**NOTICE
OSHTEMO CHARTER TOWNSHIP
PLANNING COMMISSION**

**Thursday, July 30, 2020
6:00 p.m.**

To: Oshtemo Township Planning Commission

Request: Site Plan and Special Use approval to construct a new vehicle service facility

SITE PHOTOMETRIC PLAN

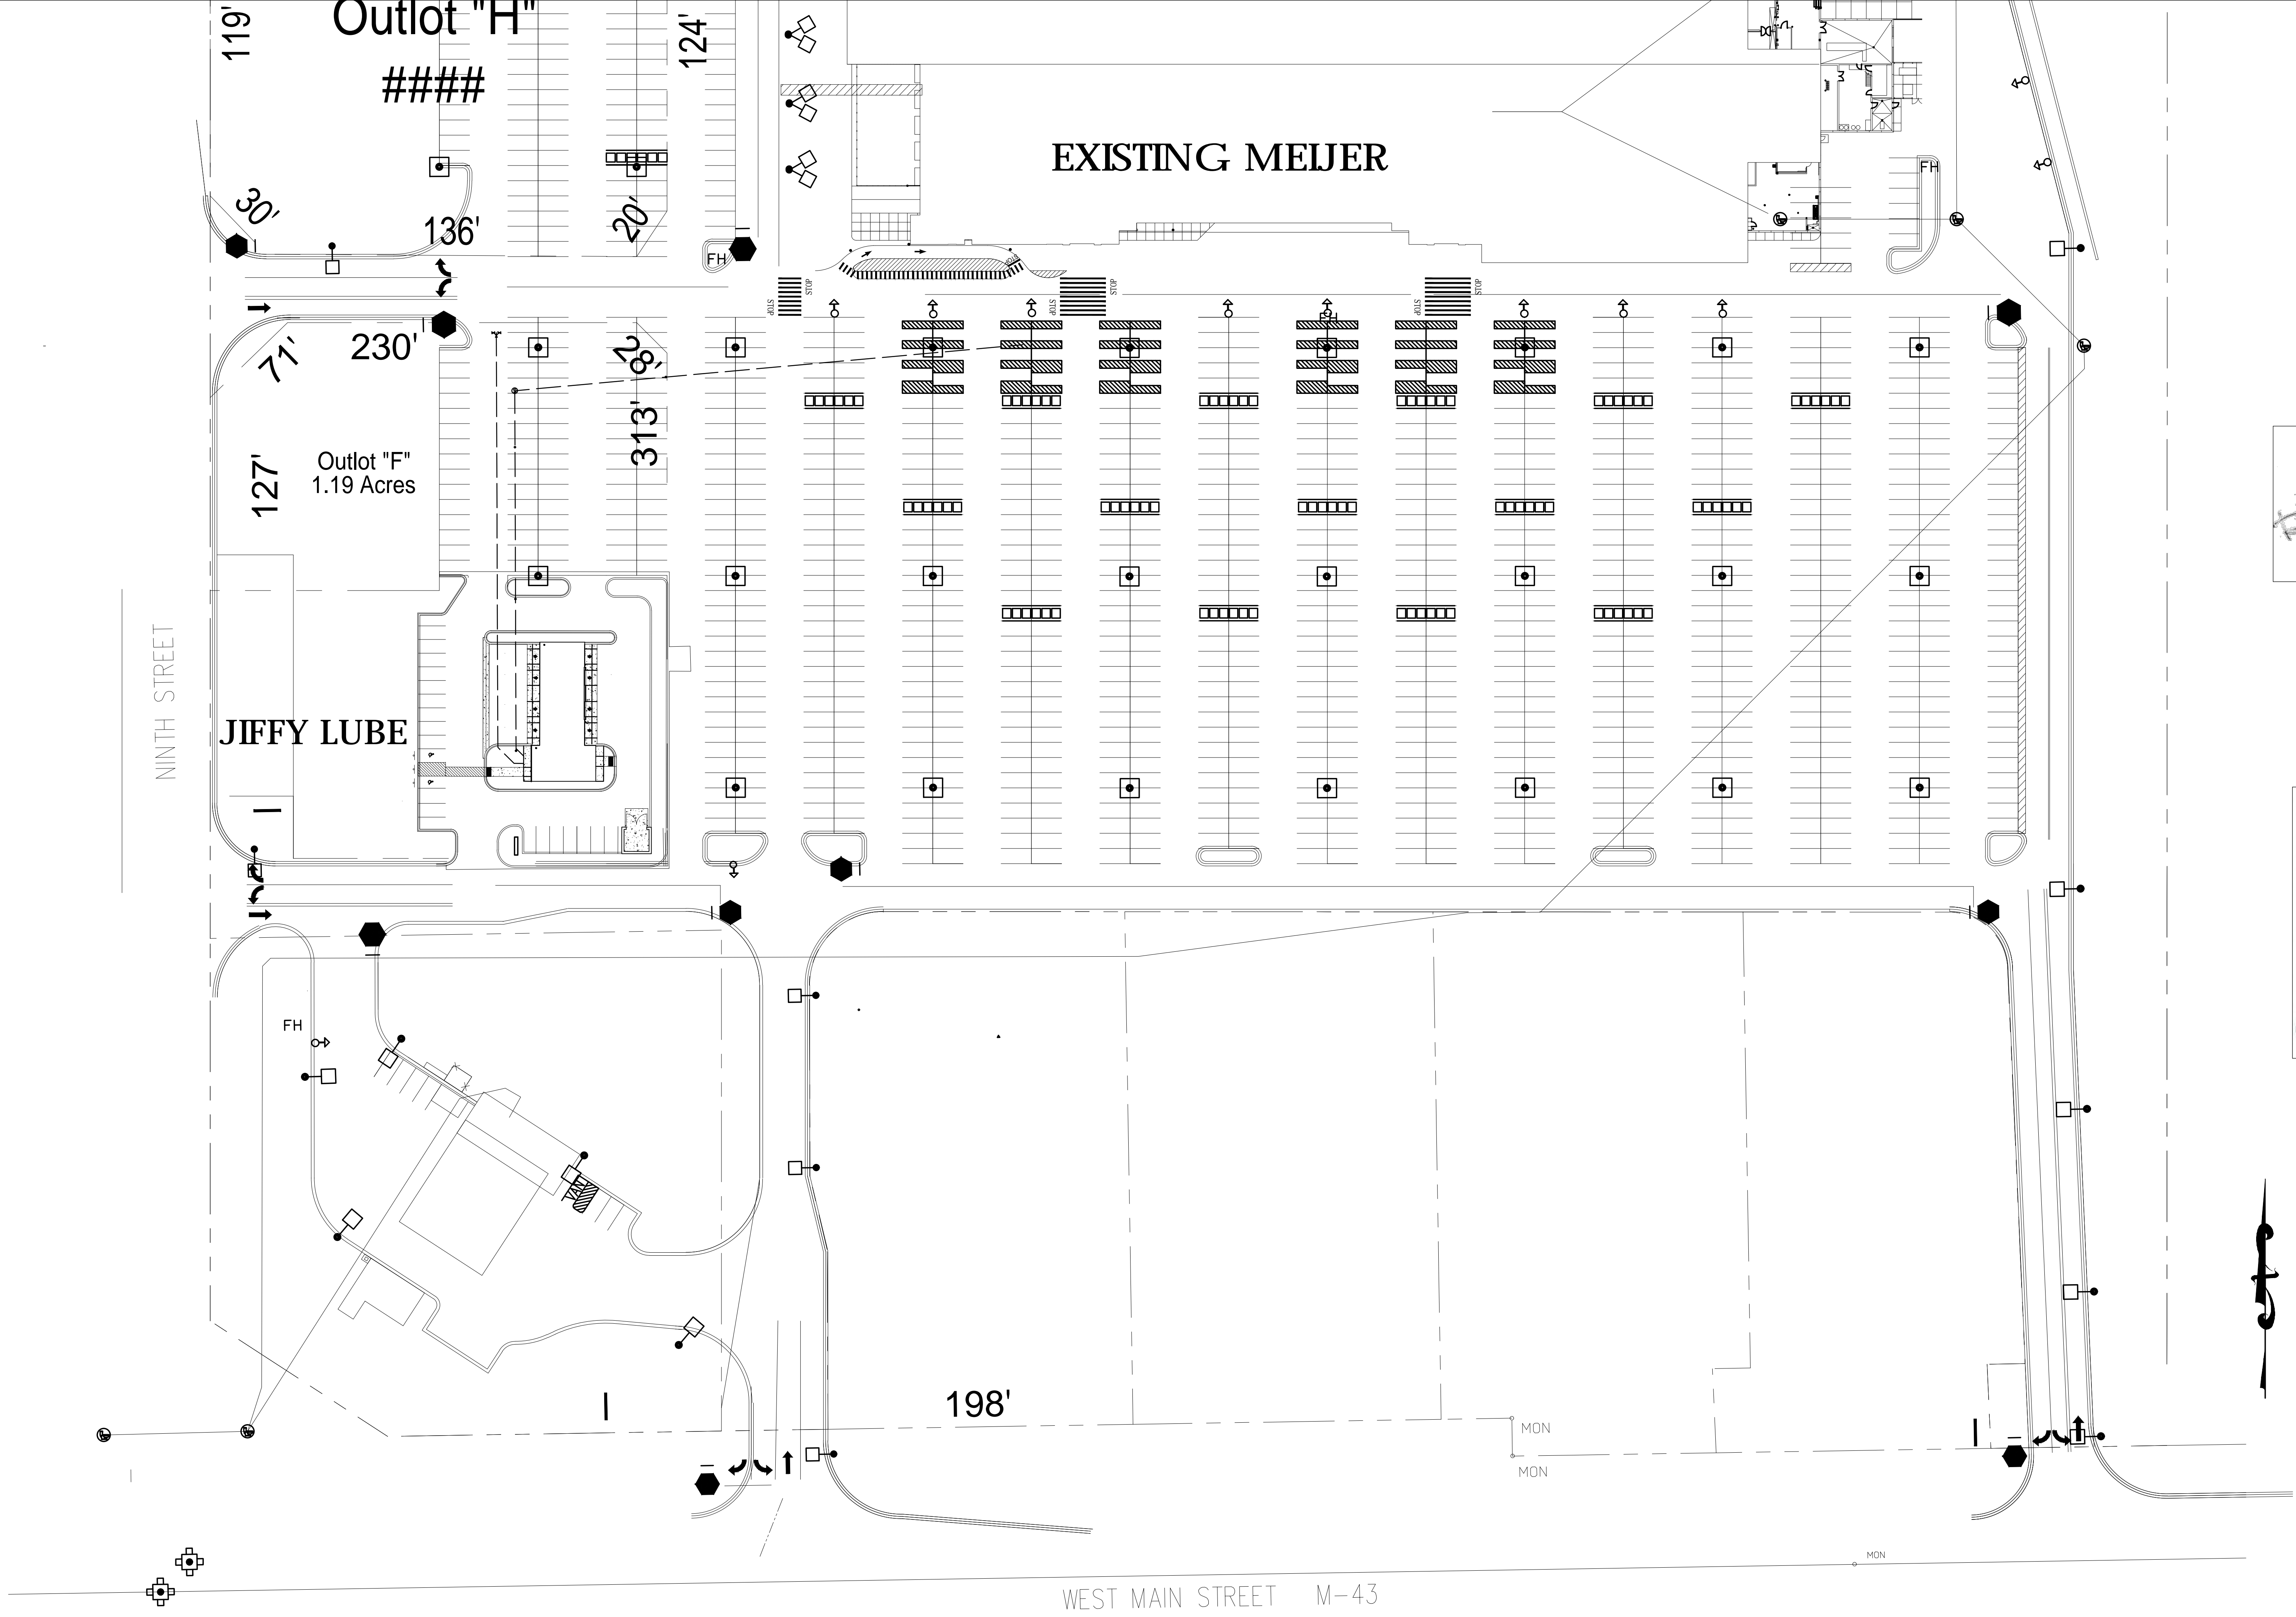
7. Updated Architectural Plans shall be provided to the Planning Department *prior to a building permit being issued*.
8. An updated Photometric Plan shall be provided to and approved by Planning Department *prior building permit issuance*. Current insufficiencies include:

- a. No cut sheets provided for the proposed lighting fixtures
 - b. The symbology is not constant with the provided schedule.
 - c. A photometric plan showing foot-candle readings every ten feet within the subject site and ten feet beyond the property lines is needed, including lighting ratios.
